DOCKET	
11-AFC-1	
DATE	MAR 26 2012
RECD.	MAR 26 2012

**Re: Pio Pico Energy Center Project (11-AFC-01)
Applicant's Comments on the Preliminary Staff Assessment**

REVISED EXHIBIT A “TRANSMISSION ROUTES” TO APPLICANT’S ADDITIONAL RESPONSES TO
STAFF’S INFORMAL DATA REQUEST REGARDING BIOLOGICAL RESOURCES

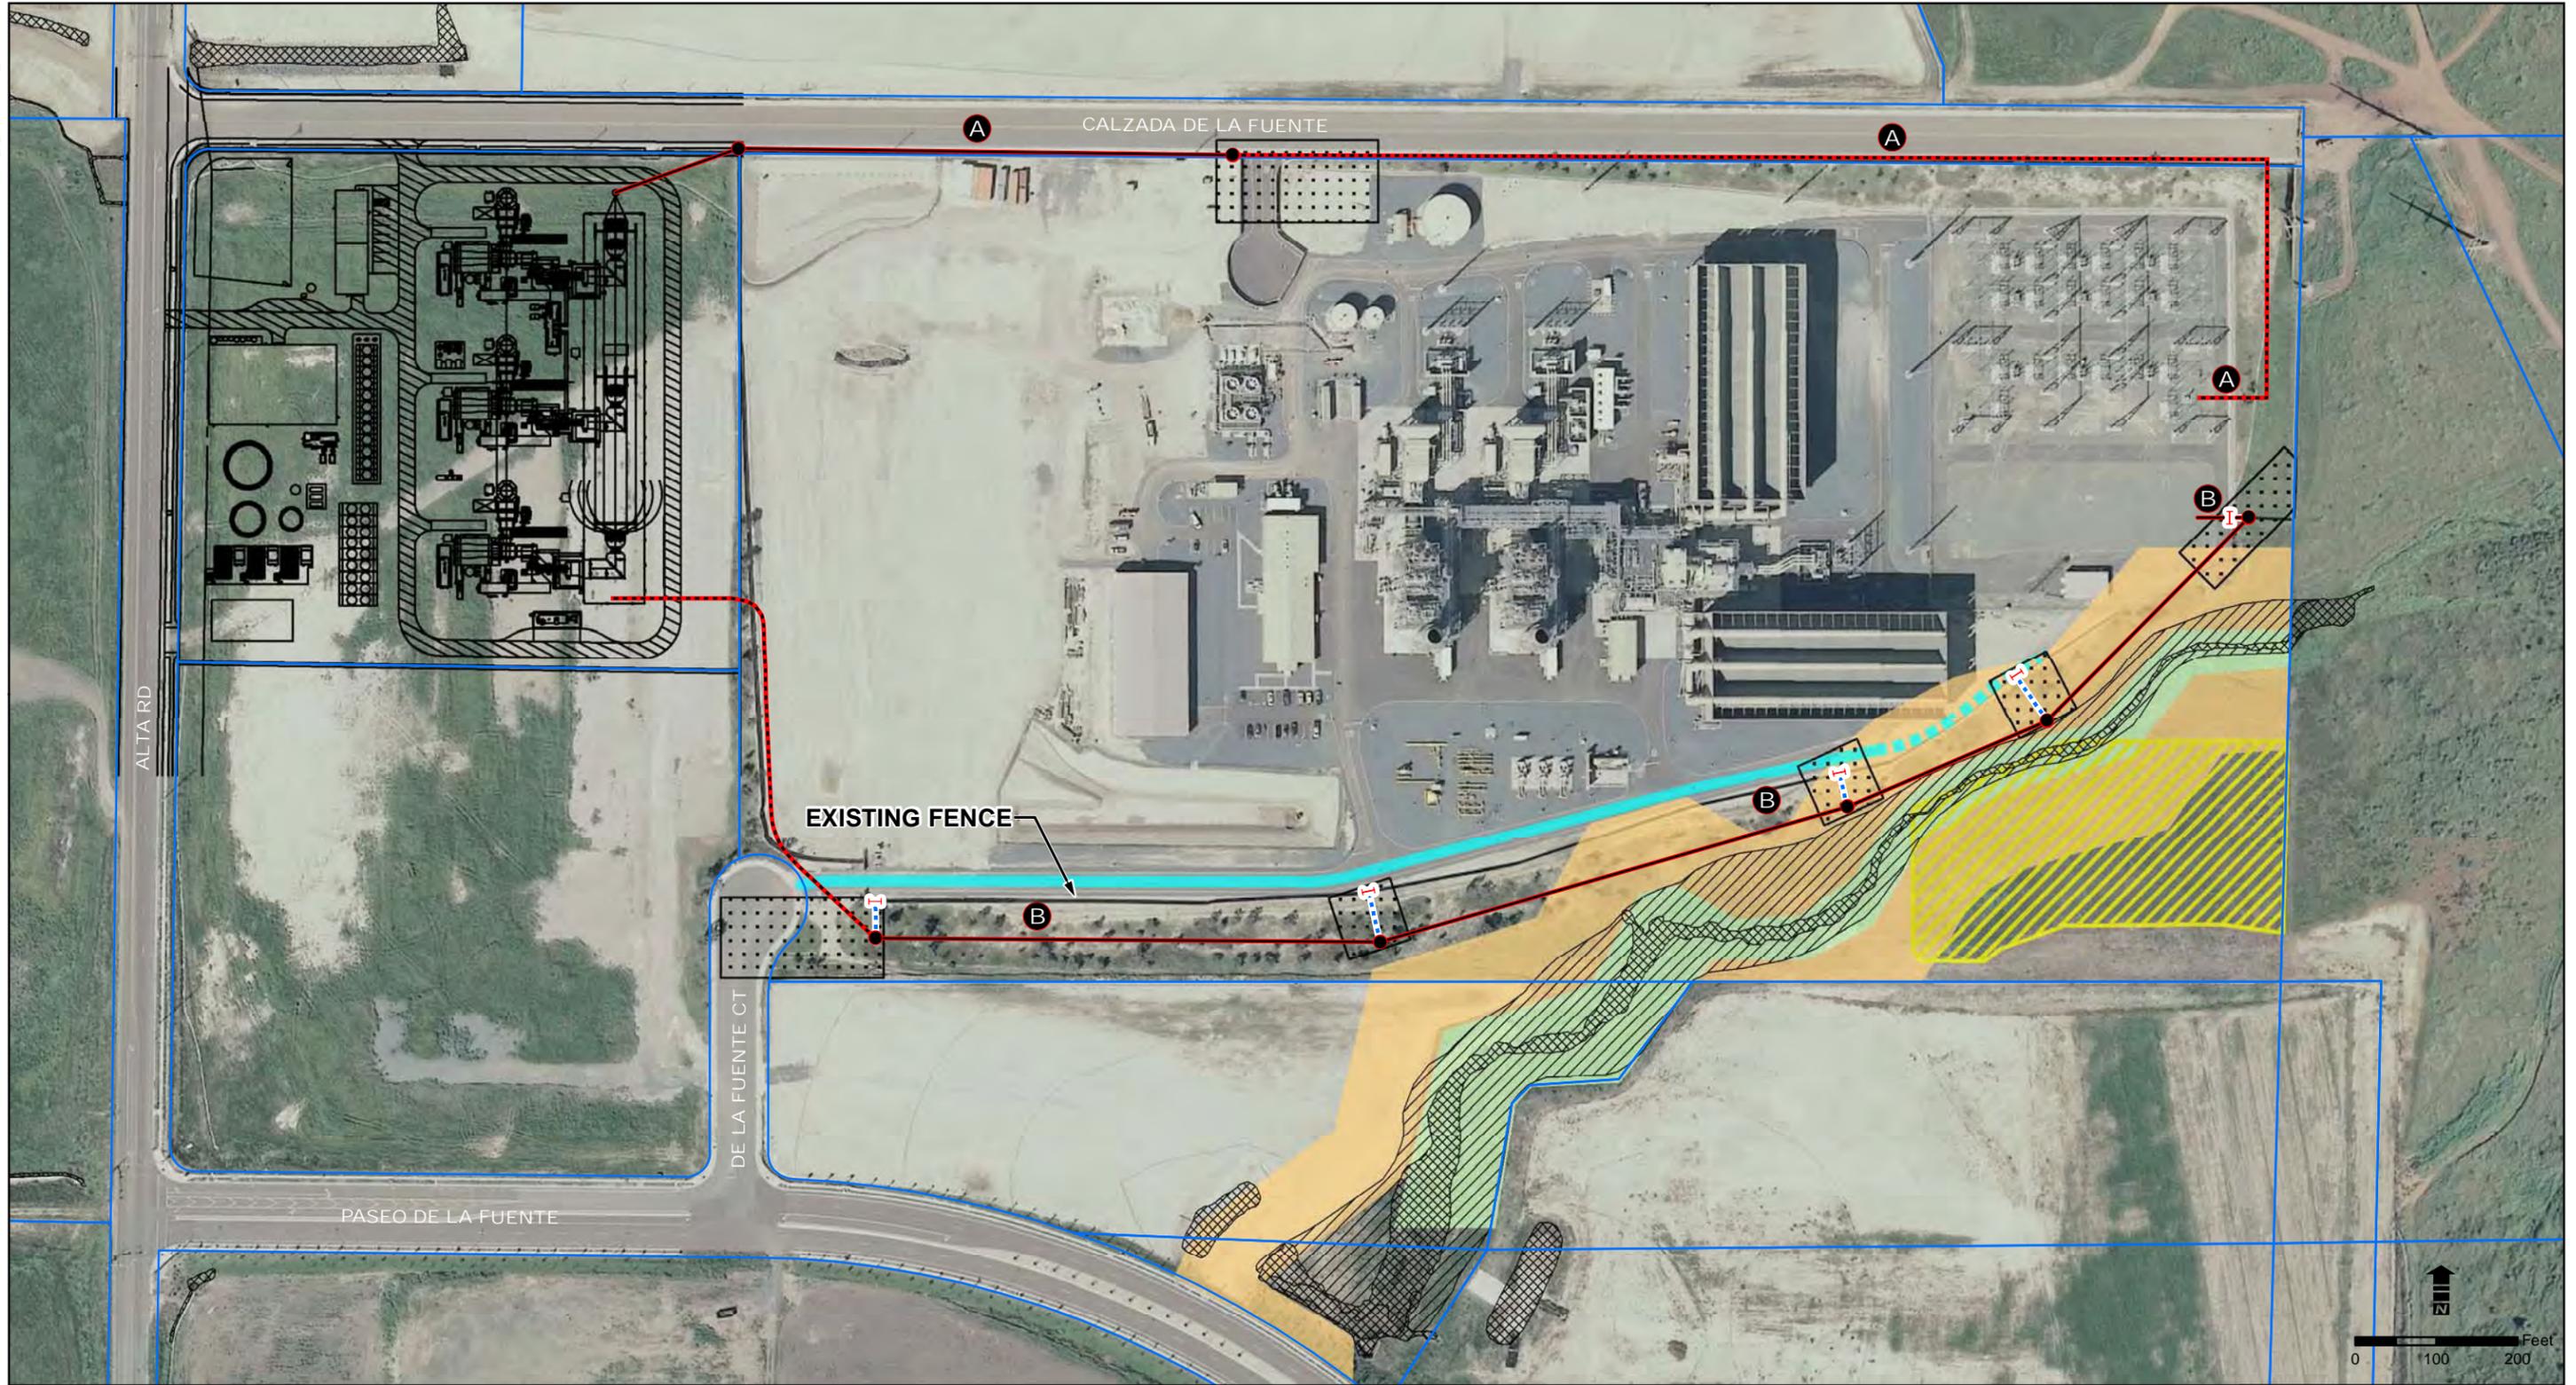
1. The text of your submittal refers to a "right-of-way," in which both construction and maintenance activities would occur; however, the proposed rights-of-way for the transmission line alternatives are not depicted on Exhibit A. Please provide a revised Exhibit A depicting the extent of the proposed right-of-way on either side of the T-line centerline (for Route B in particular). Also, please provide a text description of the precise widths of the right-of-way along either side of the T-line centerline. Will the right-of-way be equal on either side of the Route B T-line? Will the right-of-way be reduced (narrower) in the area of the easements? Also, will the existing landscape vegetation be permanently or temporarily removed to accommodate an access road?

wall that surrounds the Calpine Energy plant, thereby reducing the area available to work due to the wall partitioning the area. Please describe how it is feasible to perform the wire stringing activities (and any other construction activities) within a working area that is smaller than the 100' x 200' working area that was said to be required for the pulling equipment set-up and wire stringing activities *without imposing upon the easement areas.*

3. The submittal depicts a change in the originally-proposed Transmission Line Route B. Instead of a right angle, the proposed Route B now cuts the corner and hugs the perimeter of the Calpine plant. Please indicate whether or not this area was included in the original cultural resources survey area. If it has not been surveyed, a supplemental pedestrian cultural survey would need to be performed. It may be necessary to inquire with the other technical specialists regarding this change in the T-line Route B alternative.

Response: The ROW width is generally based on the aerial space required on each side of the conductors to avoid contact with other structures, etc. The electrical clearance for a 230 kV conductor is about 25-30 feet from a structure (other than the pole structures themselves). In between poles there has to be that extra space for the wind whipping the lines out. That is why PPEC has stated a nominal 80' right-of-way along the route.

As requested, revised Exhibit A is attached. The right-of-way in which construction and maintenance activities would occur is from Calzada de la Fuente and within the existing Otay Mesa Generating Project (OMGP) site for Transmission Line Route A and within the existing OMGP site for Transmission Line Route B. The existing road within the OMGP site has been shaded light blue on the revised Exhibit A and this road, will provide access to four of the five Transmission Line Route B work areas. The easternmost work area for Transmission Line Route B will be accessed from within the OMGP site just south of the switchyard. The work areas outside of the OMGP site fenceline along Transmission Line Route B will be accessed from within the OMGP site through access gates, which are depicted on the revised Exhibit A. There will be little to no need for vegetation removal along Transmission Line Route A or Route B with the exception of the work areas depicted on Exhibit A.

Response: Exhibit A has been revised to depict the size and location of the "Working Areas" more accurately. In some cases the working area size is closer to 100' by 100' (e.g., three of the five working area locations along Transmission Line Route B). The rest of the working areas are indeed approximately 100' by 200'. The working areas will have access gates along the OMGP fenceline for access to the working areas from within the OMGP site. The proposed working areas may be able to be reduced after detailed design is complete and construction work plans are finalized. The initial lead line will be walked through the areas between the poles. The lead line is then raised up the pole onto pulleys, and used to pull the permanent conductors into place. There is no Construction work along the right of way except to place the poles and do the pulling work at each end. Some vegetation around the pole locations will be affected. Impact along the right of way to vegetation will be minimal to negligible.

Response: The Cultural Resources lead, Rachael Nixon provided confirmation to the project owner that the area in question was surveyed during the original AFC pedestrian survey. The modification to Transmission Line Route B are a direct result of avoiding cultural resources within a known Conservation Easement which was directly coordinated between the Energy Commission Staff Archaeologist (Sarah Allred) and the project owner. Additionally, per conversations between Sarah Allred and Rachael Nixon the survey area in question was discussed and determined to have been adequately surveyed for cultural resources. However, due to the proximity of Transmission Line Route B to previously document cultural resources the area should be monitored for cultural resources during all ground disturbing and stipulated in the Cultural Resources Mitigation Monitoring Plan (CRMMP). Based on this information no additional cultural resources pedestrian surveys are required in this area.

Response: Access to the Transmission Line Route B will be from De la Fuente into the OMGP site. Once within the OMGP site, access to the working areas outside of the OMGP fenceline will be through access gates depicted on the revised Exhibit A. The existing road within the OMGP site has been more clearly depicted on the revised Exhibit A by shading it blue. Access to the easternmost working area along Transmission Line Route B will also be from within the OMGP site on the paved area just south of the switchyard. The three easternmost Transmission Line Route B working areas will lie within "Easement in favor of the County of San Diego for Fire Buffer" areas. All other easement areas will be avoided.
